**Permit Application Review Report**  
**Date: 3/4/2026**

**Project Name:** CSAH 10 Pavement preservation

**Project PAN:** P-26-009

**Project Purpose:** reclamation and median grading of CSAH 10

Figure 1: Project Location

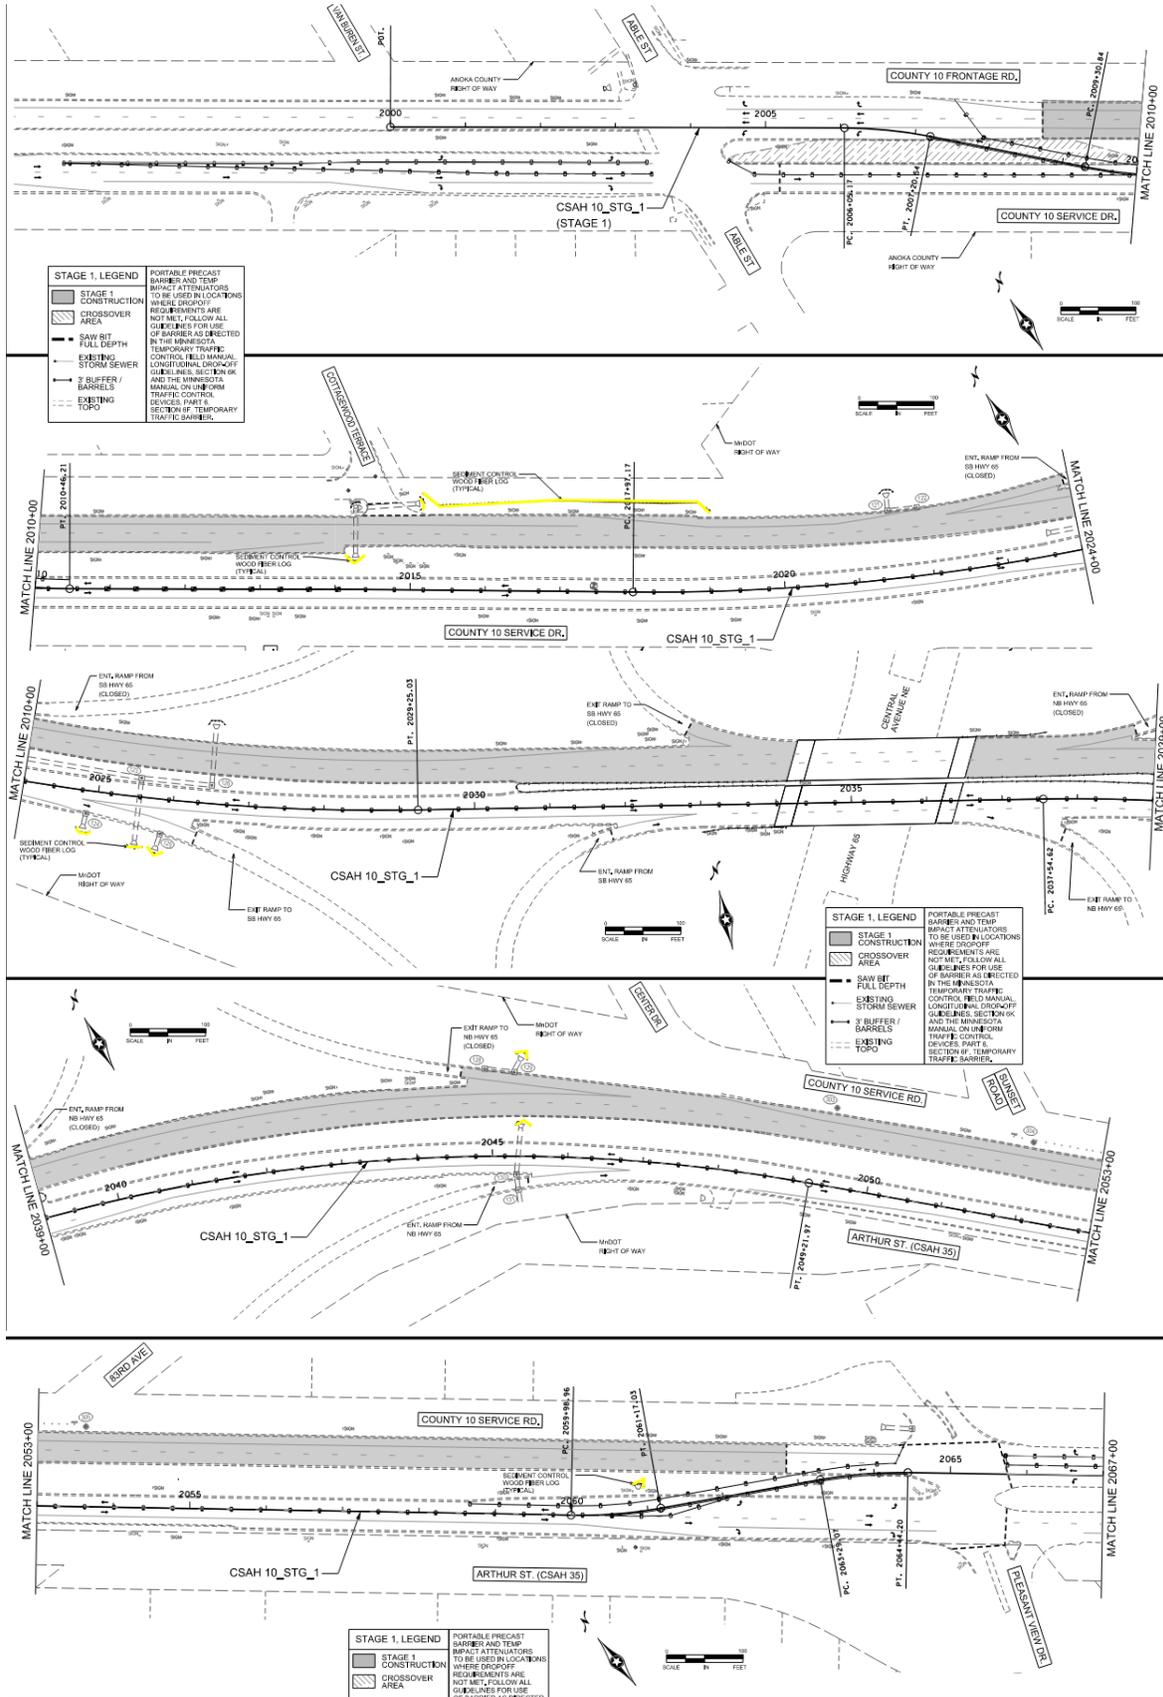
**Description:** Anoka County is proposing pavement rehabilitation and minor median grading on CSAH 10 near Hwy 65. The project will disturb 0.76 acres and drains to Springbrook Creek. The relevant water resource concern is soils and erosion control which is District Rule 4. See attached Figure 1: Project Location.
